Metro-Inner North Joint Development Assessment Panel Agenda

Meeting Date and Time: Thursday, 23 February 2023; 9.30am
Meeting Number: MINJDAP/173
Meeting Venue: Electronic Means

Development Description:	Additions - Motor Vehicle, Boat or Caravan Sales and Motor Vehicle Repair to existing Automotive Sales
Applicant:	Planning Solutions
Owner:	Carriage Equity Pty Ltd
Responsible Authority:	City of Stirling
DAP File No:	DAP/22/02366

Alternate Recommendation for Approval Conditions – Applicant Response

Attachment 1
Updated Site Plan

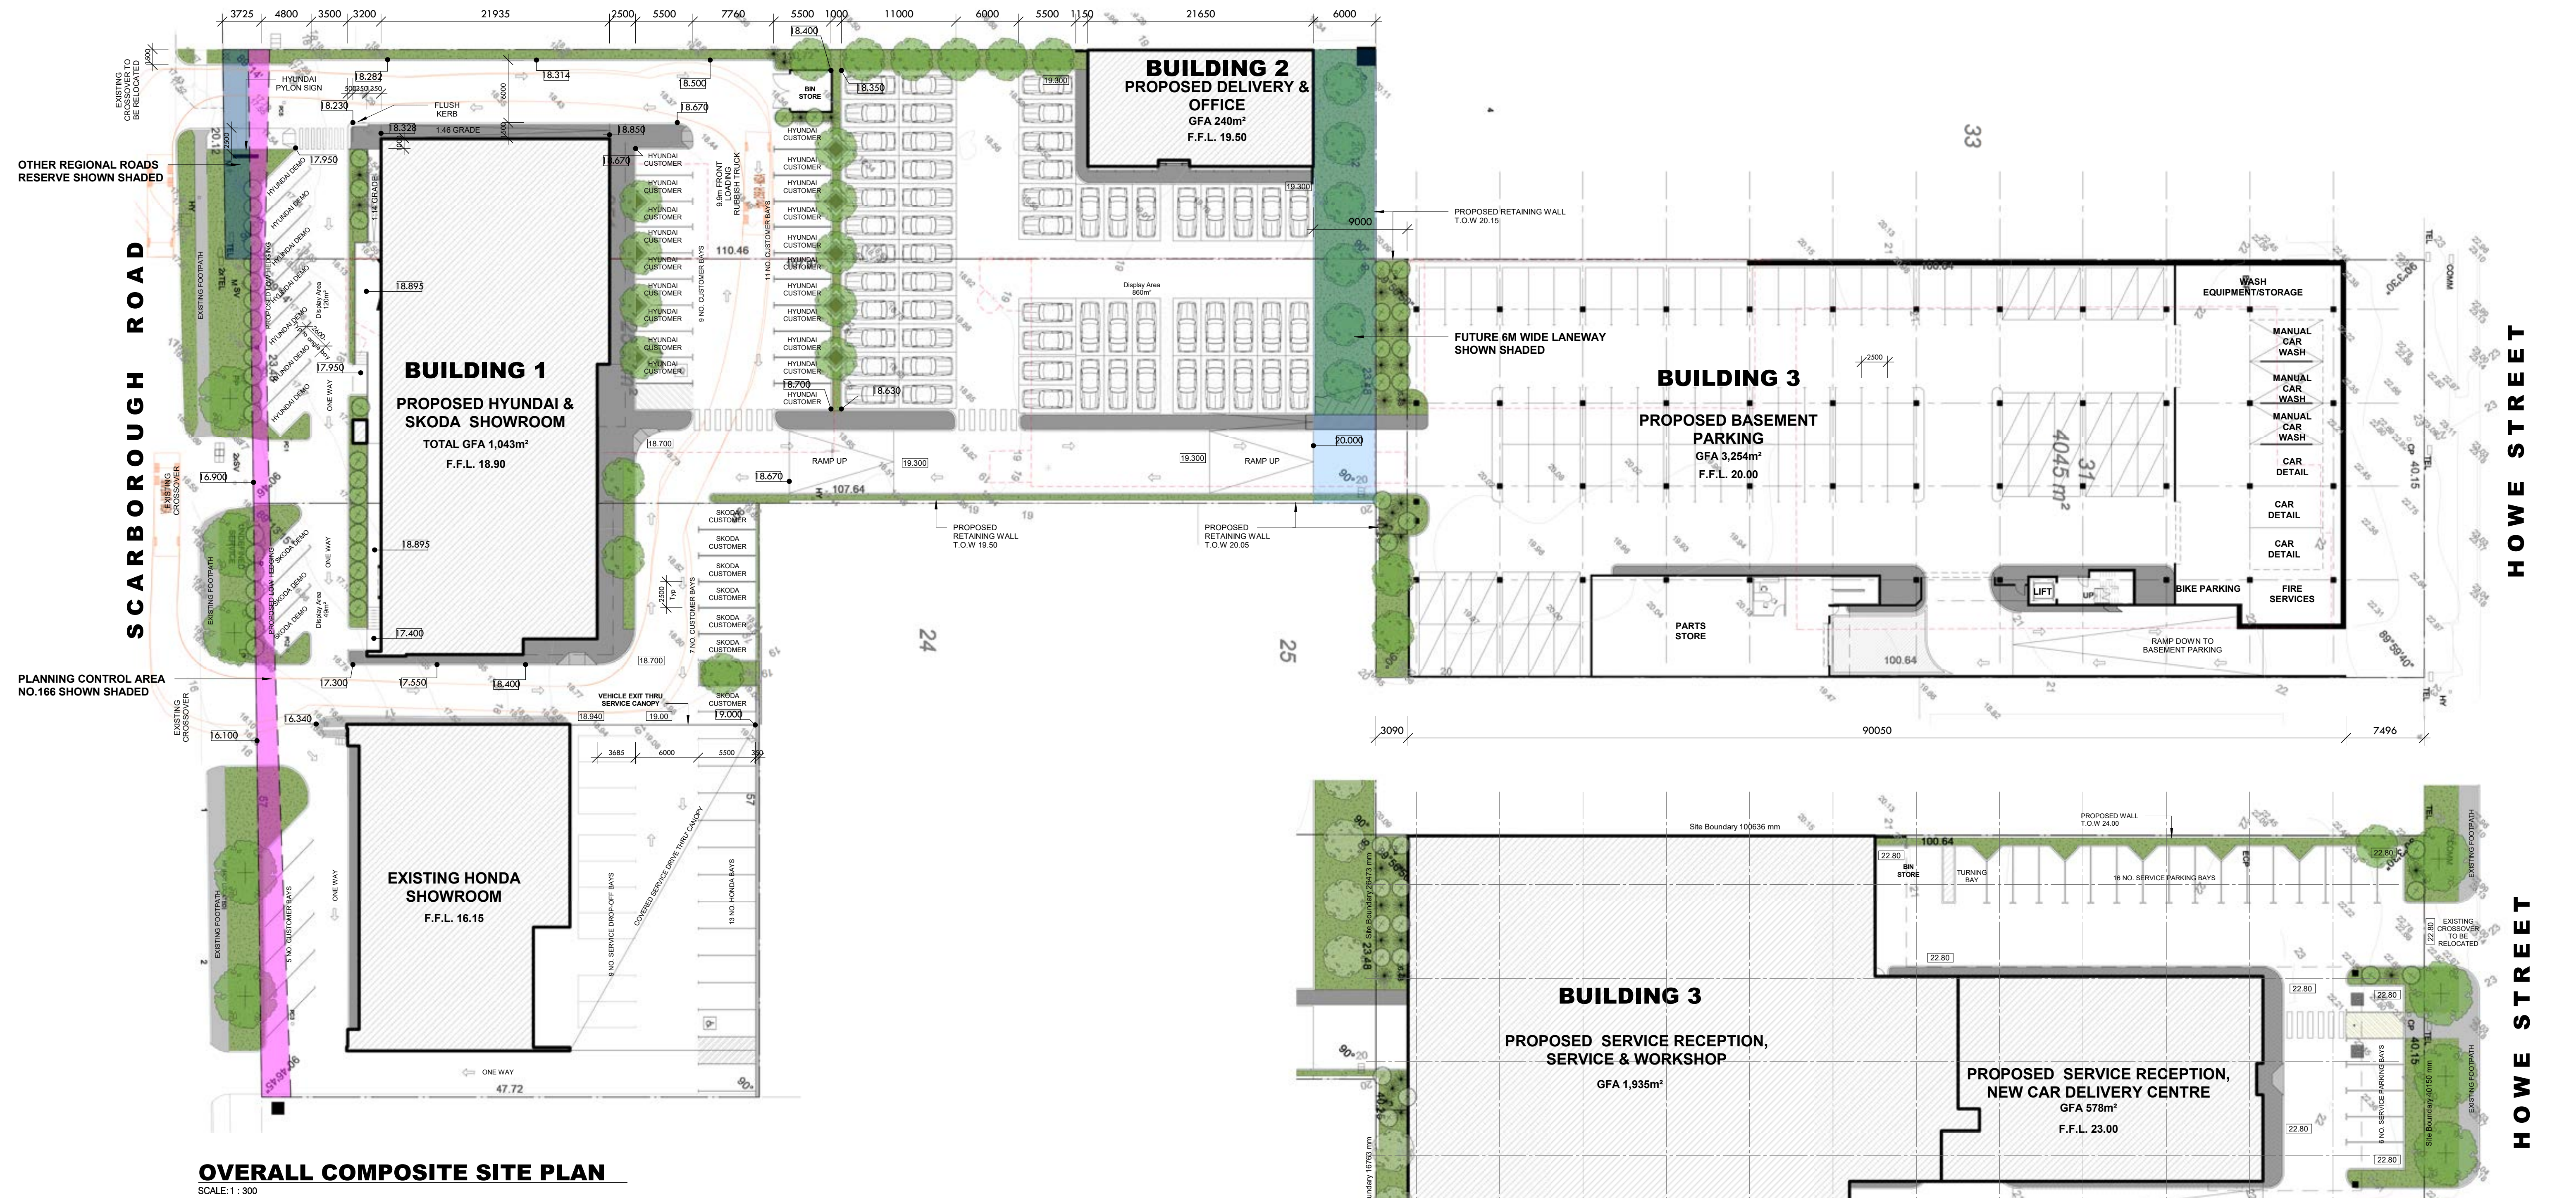
- The City's objections to the proposed building street interface are based on an LDP which is not yet operative. Not does the City give adequate consideration to the genuine merits of the proposed building design and overall improvements to the streetscape.
- The City's objections to the proposed landscaping are unwarranted given that landscaping provision are compliant based on a recalculated site area that excludes the retained Honda showroom.

We respectfully request the JDAP sets aside the City's recommendation and grants approval to the proposed development, subject to the appropriate conditions.

Lack of display bays in front of development pushes car parking into the verge.

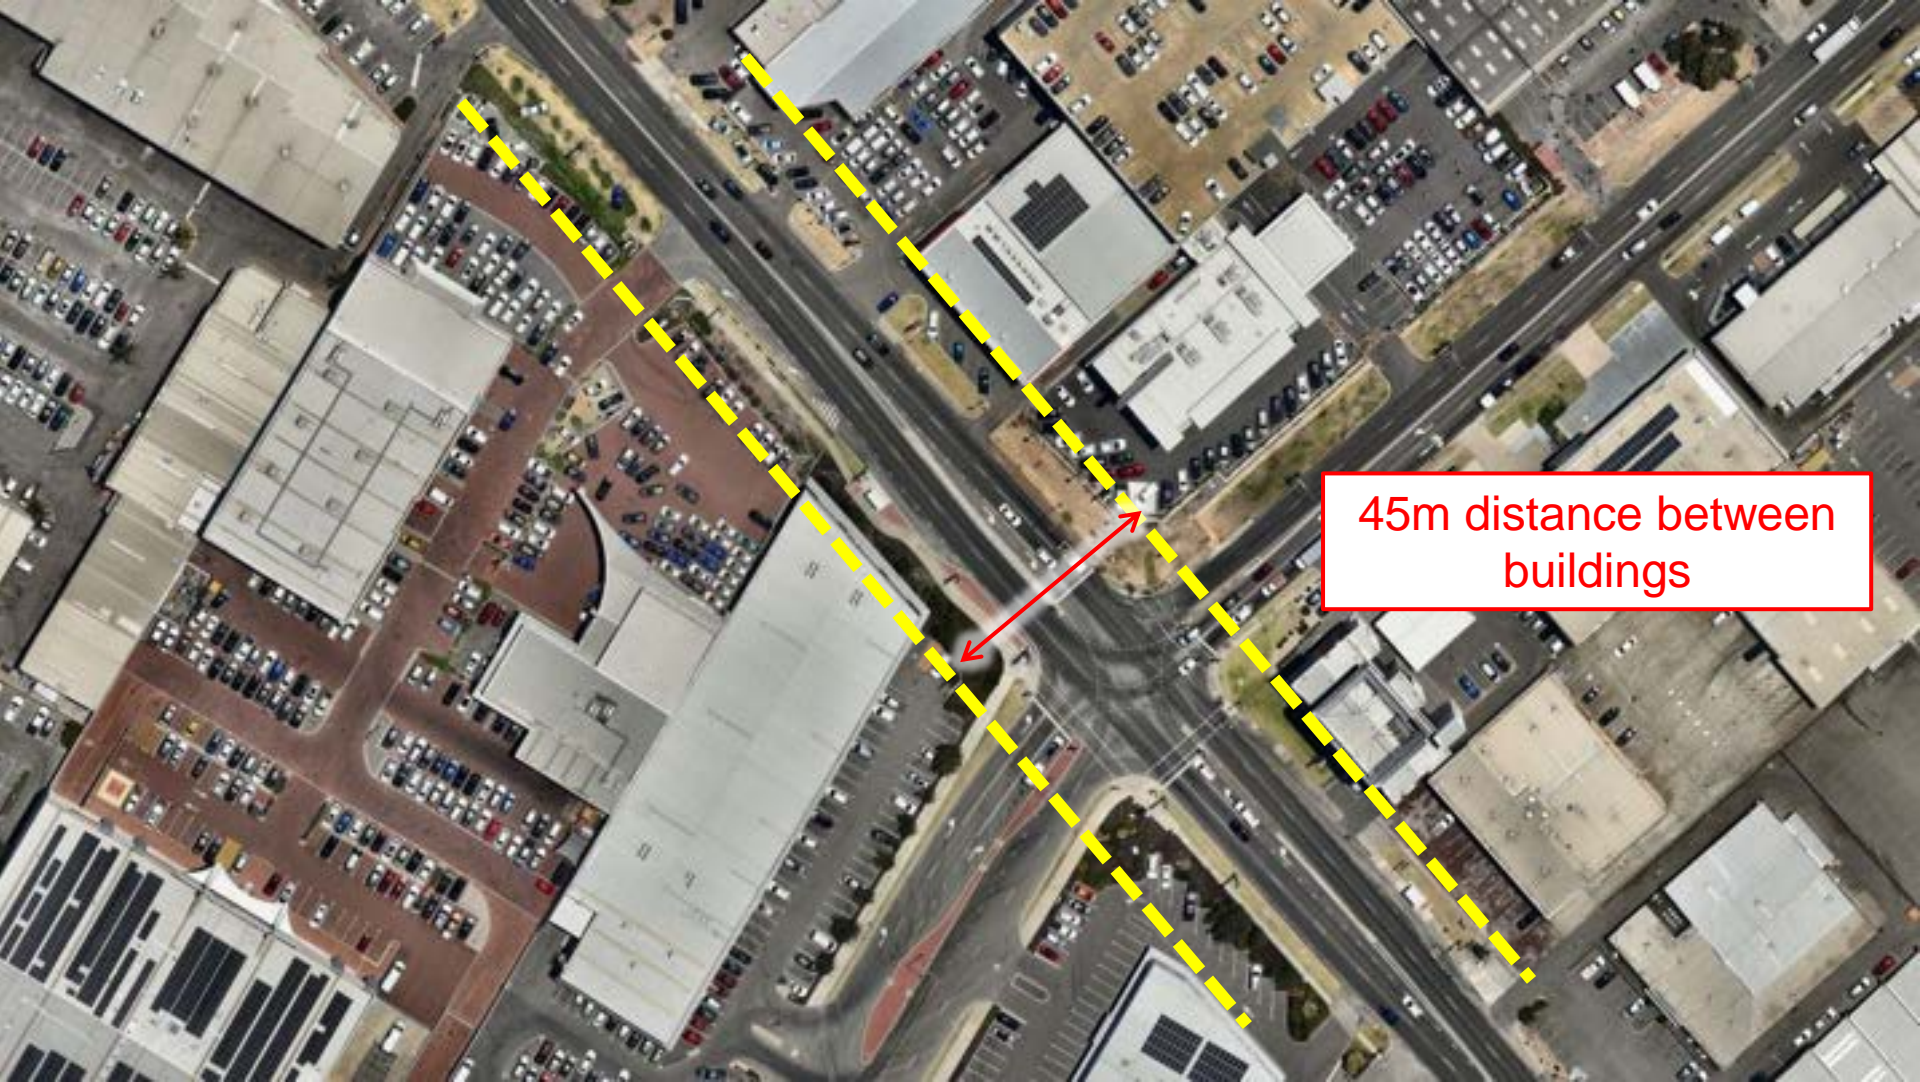
45m distance between
buildings

Figure 2 – Annotated extract of the Herdsman Glendalough Mandatory Residential Plan from the draft HGSP

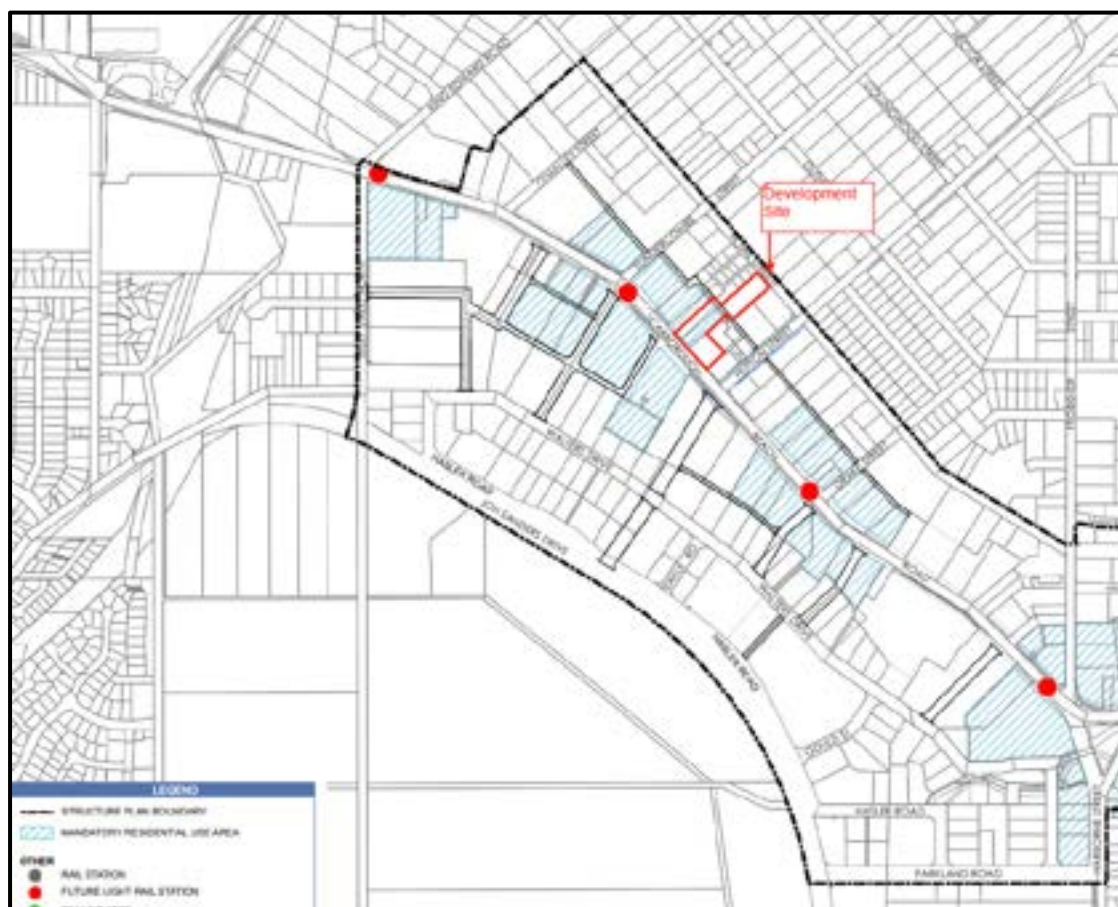
Figure 26 of the Draft HGSP indicates that HN 438 and 440 Scarborough Beach Road are located within the Mandatory Residential Use Area.

While the Mandatory Residential Use Area is identified as applicable to the site, the proposed works constitute non-substantial development and therefore the delivery of a residential component is not required as part of this application. An assessment against Clause 6.2.1 of the draft HGSP has been provided in following section.

Figure 3 – Annotated extract of the Herdsman Glendalough Movement Plan from the draft HGSP

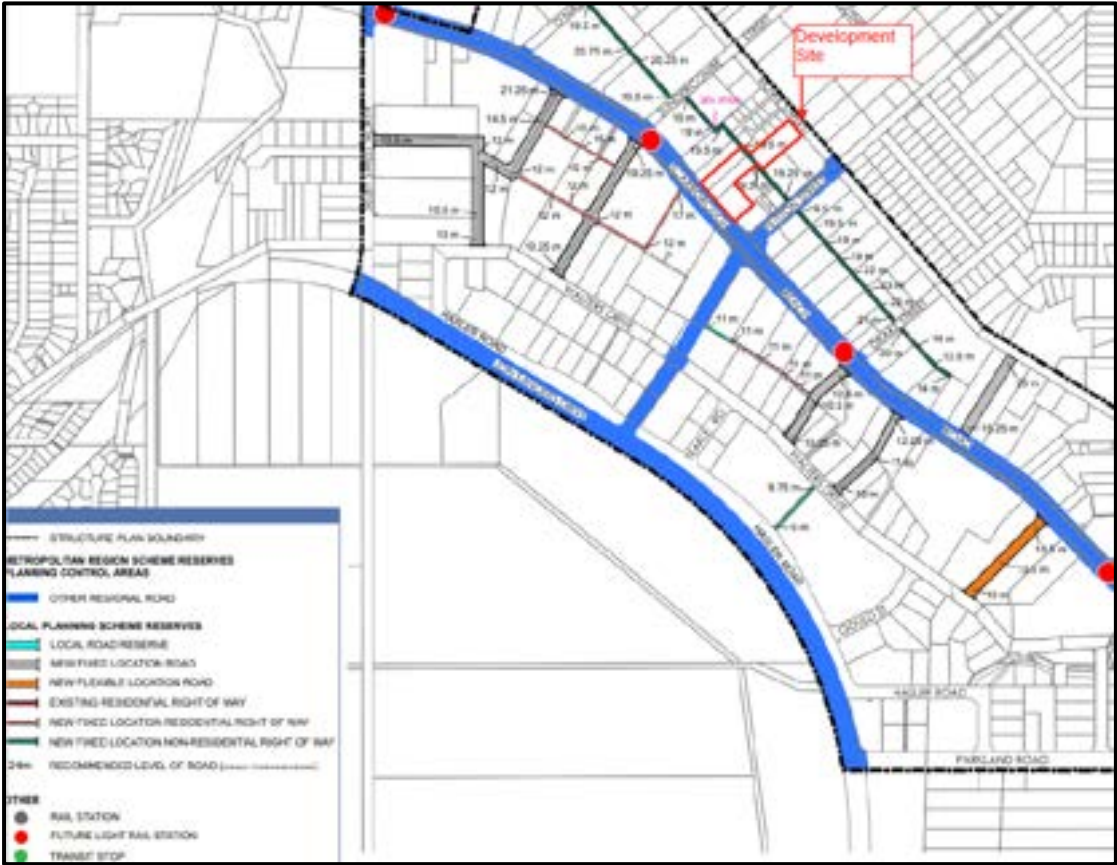
As per Figure 13 of the draft HGSP, a new fixed location of a non-residential Right of Way (ROW) is proposed to the rear of the subject site facing Scarborough Beach Road, which is required to be ceded and constructed as per Clause 6.1.3 of the draft HGSP.

While a future non-residential Right of Way (ROW) has been identified through the site, the proposed works constitute non-substantial redevelopment and has been assessed against Clause 6.2.1 of the draft HGSP in the below table.

Additionally, it is noted that Figure 13 requires the Relative Level (RL) of the future Right of Way to be 19.5 in this location. The RL is proposed at 20.00. The City's Engineers have reviewed the proposed grade and levels and have advised that a RL of 19.5 and compliant grades are able to be achieved on the vehicular ramp internal to the site without impacting the built form. As such, the City recommends a condition relating to the RL of the Right of Way, should the JDAP be of a mind to approve the development.
